DISCRETIONARY REVIEW ABBREVIATED ANALYSIS

Record No.: 2018-014950DRP
Project Address: 492 45th Avenue
Permit Applications: 2018.1022.3827
Zoning: RH-1 [Residential House, One-Family]
40-X Height and Bulk District
Block/Lot: 1491 / 001D
Project Sponsor: Hawk N. Lee
1609 Noriega
San Francisco, CA 94122
Staff Contact: David Winslow – (628) 652-7335
david.winslow@sfgov.org

The project proposes to construct a second story vertical addition and a front horizontal addition to an existing 1-story, single family house. The project also proposes the demolition of the attached one-story structure in the rear yard at the north east corner of the lot.

Figure 4. Proposed New Second Floor Plan

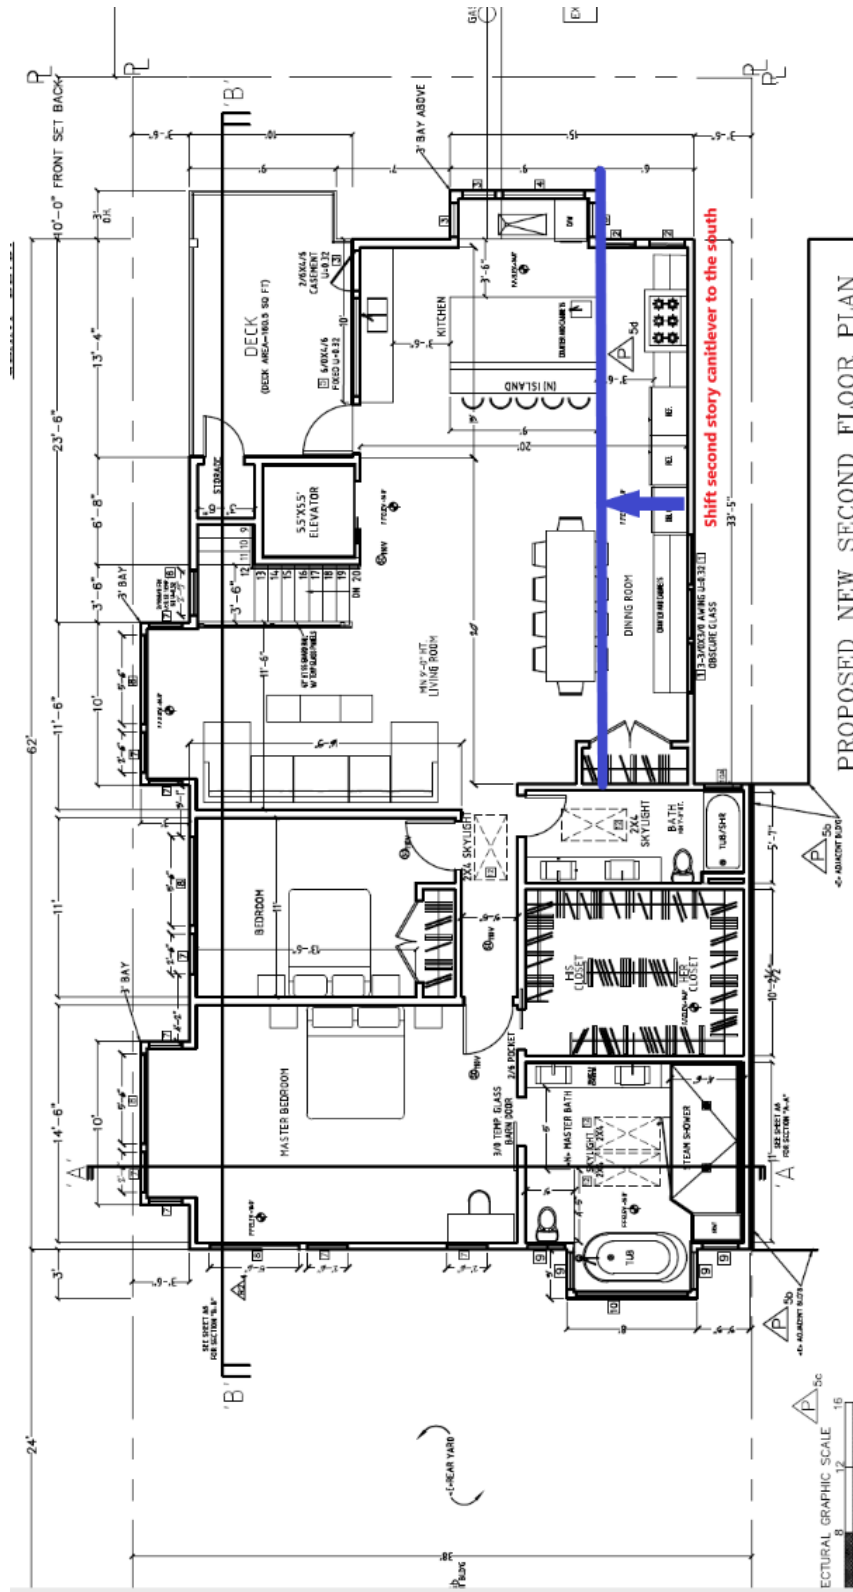
The project would reduce access to light and air on the south side of the neighbor's home. The project has been insensitively designed. As show in in *Figures 3* through *4*, the proposed second story would be expanded horizontally six feet over the existing first story to the north towards the Treuille's home. A 13'-6" second story would be constructed over the existing 14' first story. As shown in *Figure 5*, the second story would tower approximately 7' above the top of the Treuille's south-facing second story windows, which would significantly reduce light to these windows. The placement of the proposed solar panels could further impact their light.

Increasing the height and width of the building would drastically reduce the light and air that the neighbors currently enjoy from the south-facing windows of their home. Most importantly, it would adversely affect the family room where the children and their parents will be spending the bulk of their time during the day. (At present, the Treuilles are still unpacking.) **Figure 6** is a photograph of Cullan Treuille in the playroom. You can see the light that currently comes in the window and the existing first story home at 492 45th. Now imagine a second floor that is six feet closer to the playroom (**Figures 3 and 4**) and rises 13 ½ feet higher (**Figures 3 and 5**).

The project is proposing to provide a greater side setback to the neighbor by moving the second floor 3’ further to the southern property line as exhibited in revised plans dated 11.8.2020.

Figure 5. Proposed New North Elevation

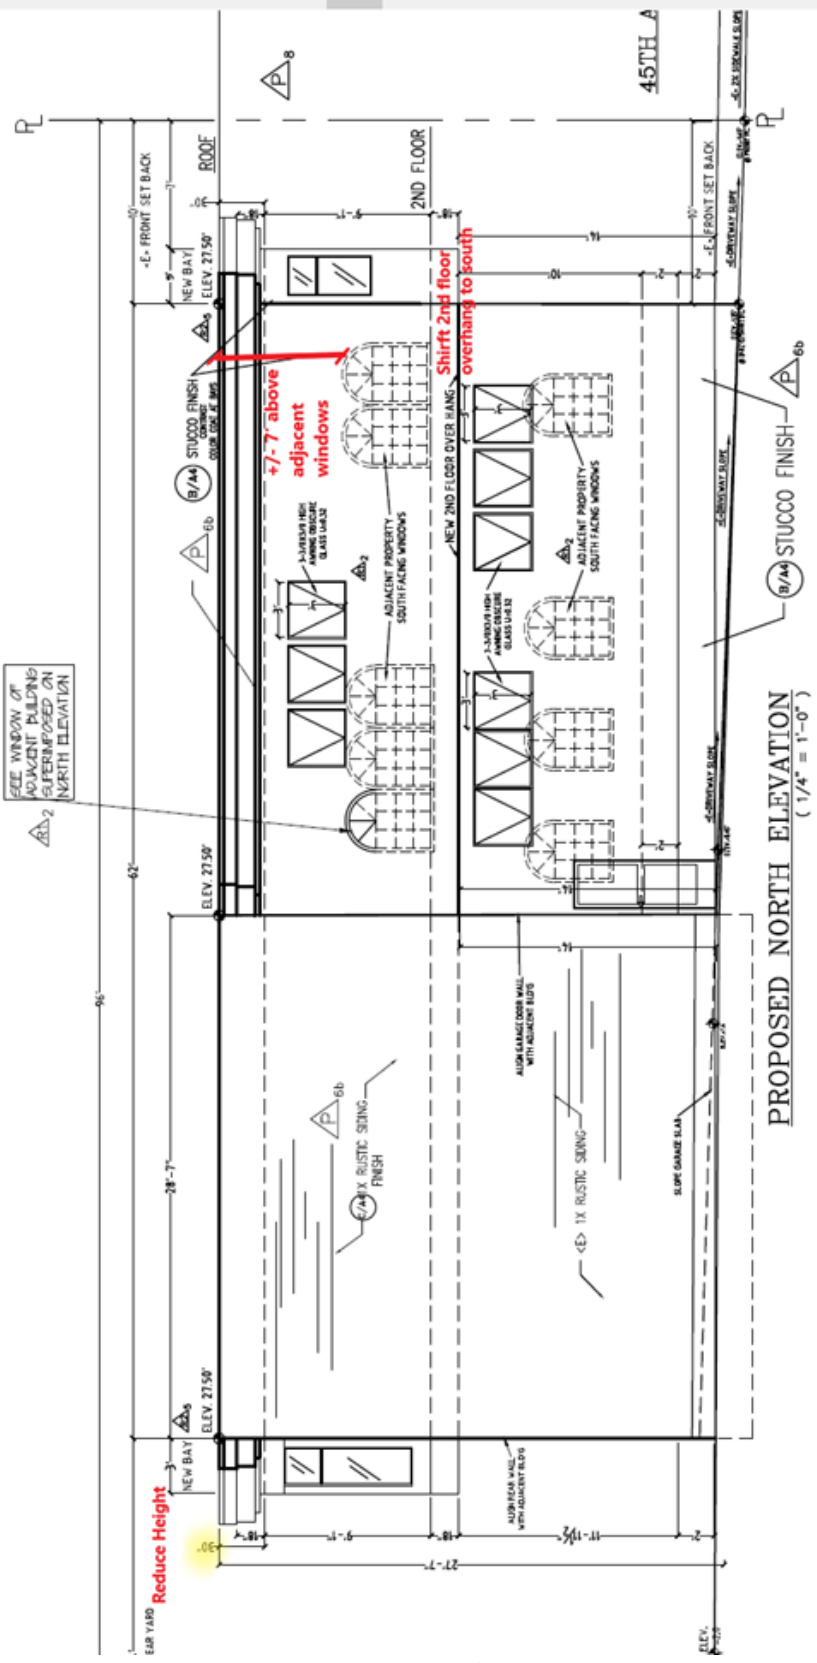
The project should be modified to reduce the proposed horizontal and vertical addition at the second floor. The overall height of the project, which is 27'-6" – 14' at the first floor and 13'-6" at the second floor could be reduced and the horizontal extension of 6' cantilevering over the first story towards the Treuille's home could be shifted to the other side of the property and/or reduced in size. *Figure 4* shows the portion of the proposed addition that could be shifted to reduce impacts. *Figure 5* shows that the extensive height of the project could be reduced by 3' or more to reduce impacts. Additionally, the table below and the floor plan in *Figure 4* demonstrate that there is ample room to modify the project to lessen the impacts on their neighbors.

PROPOSED NORTH ELEVATION
 (1/4" = 1'-0")

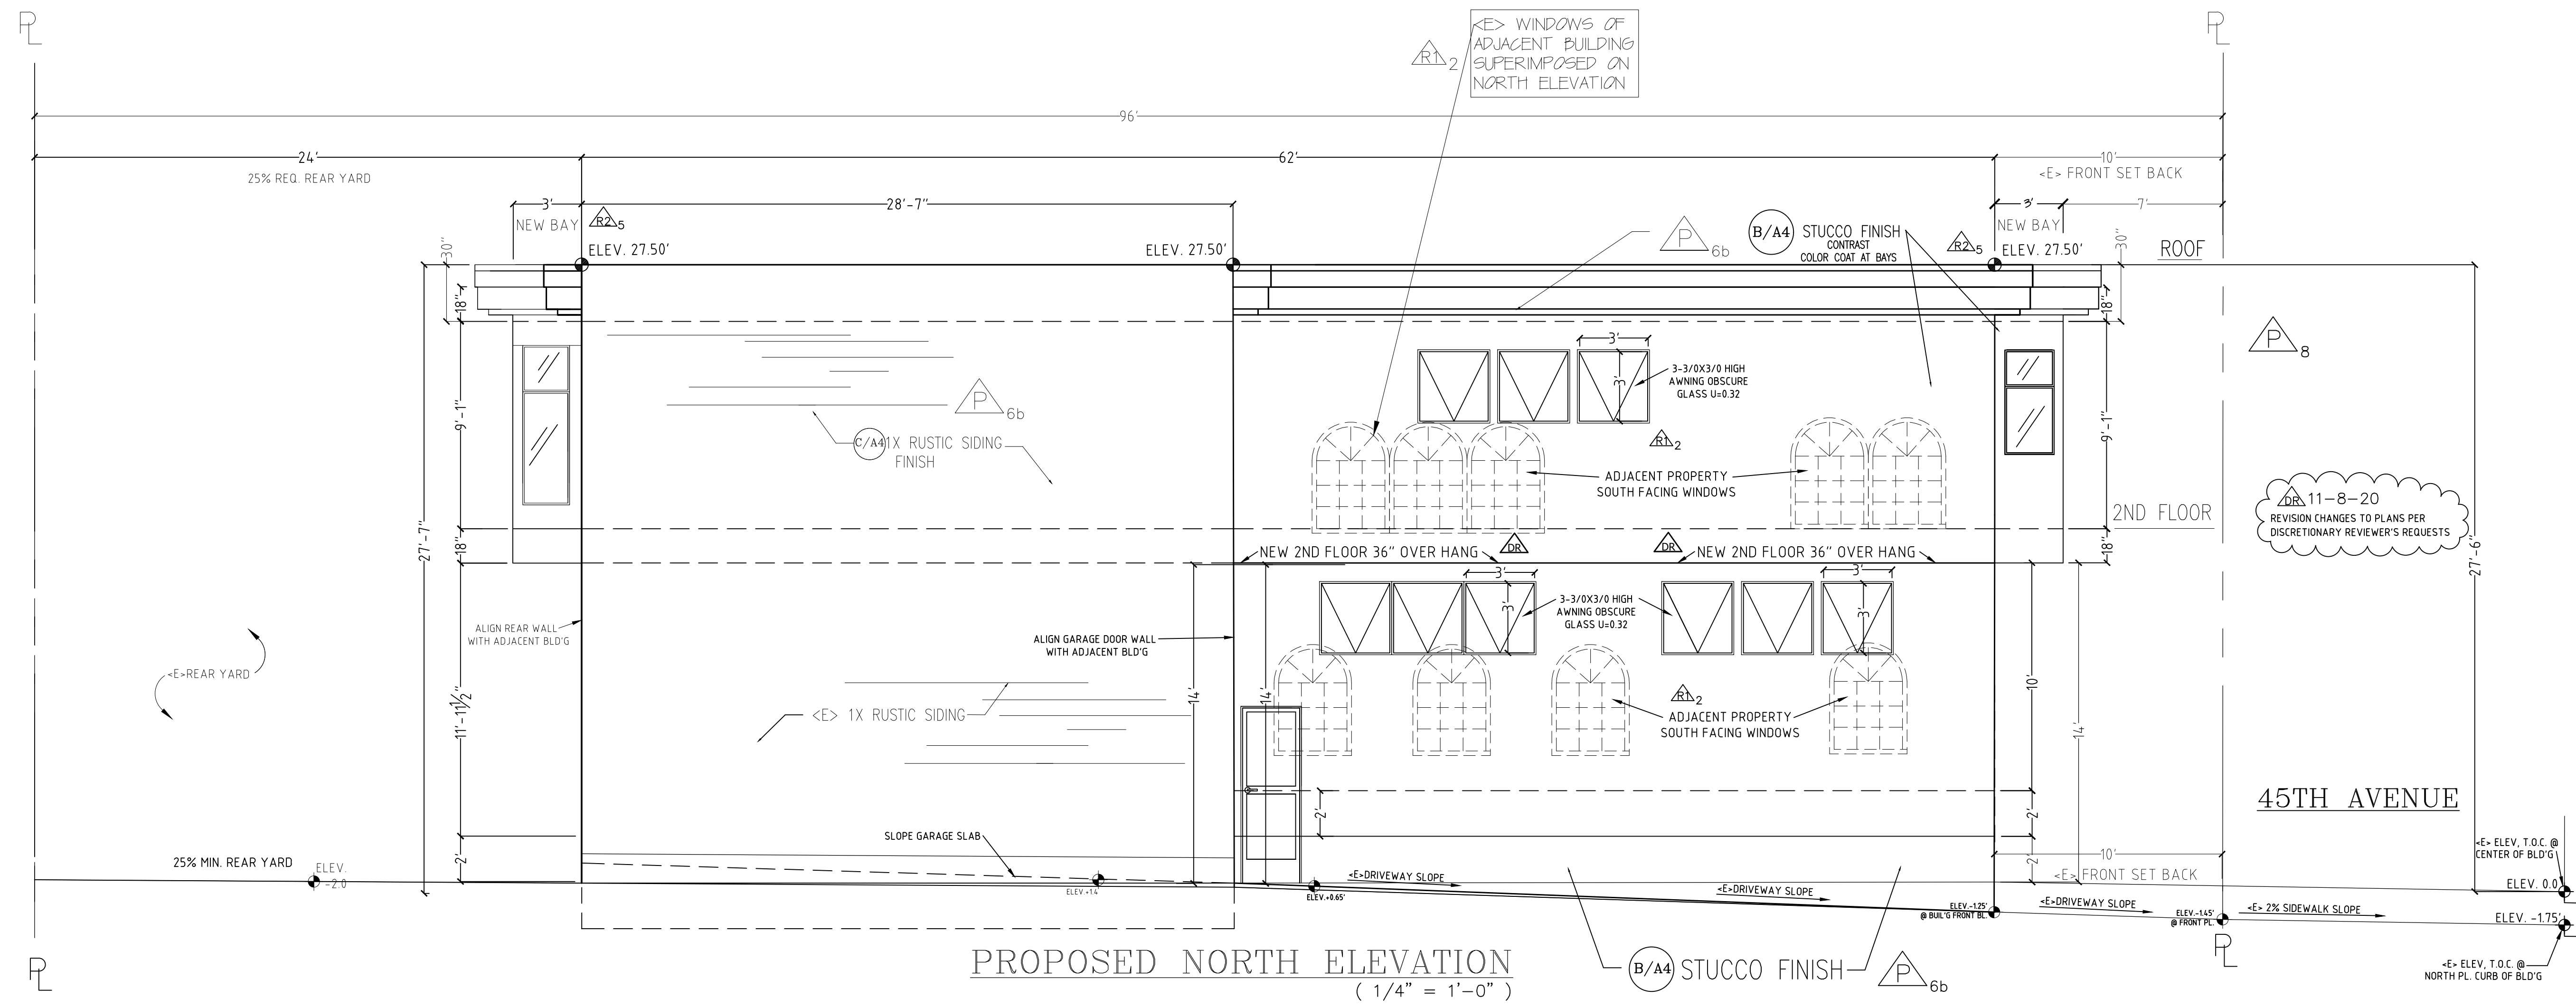
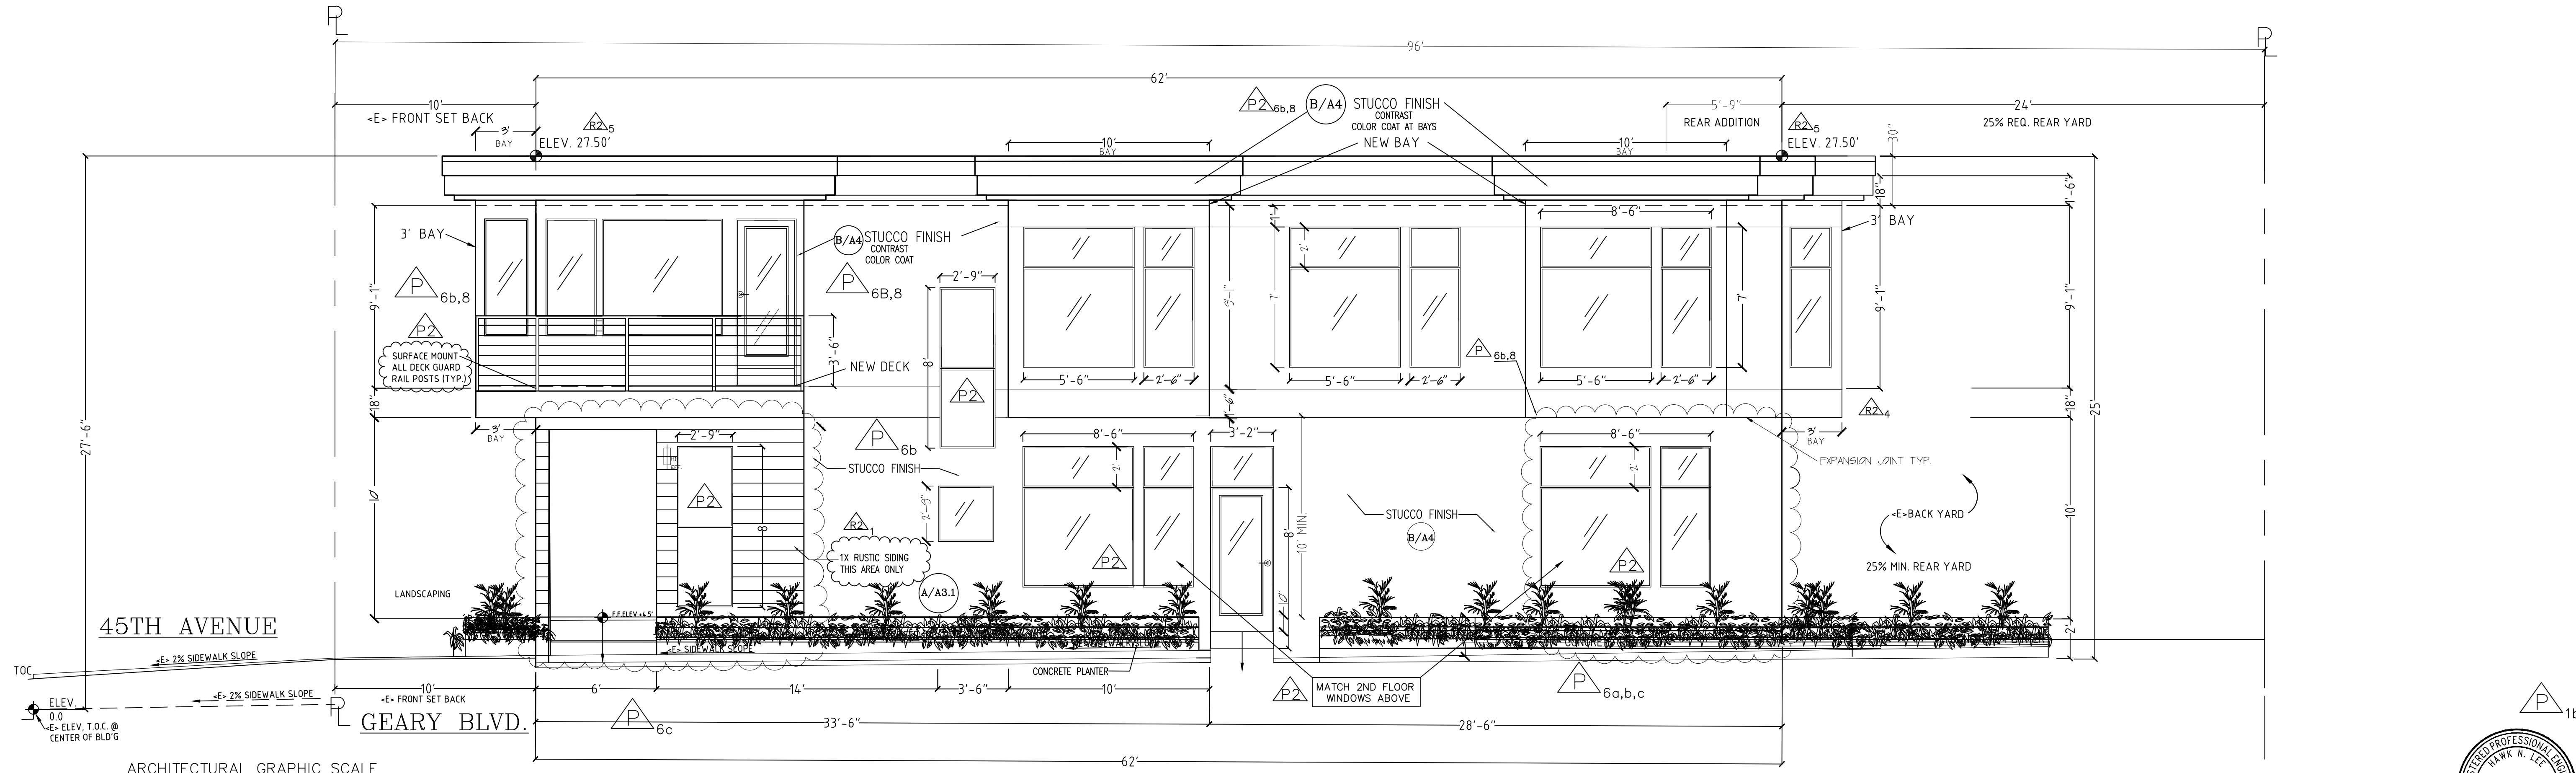
1. The top floor should be set back or reduced from the north property line.
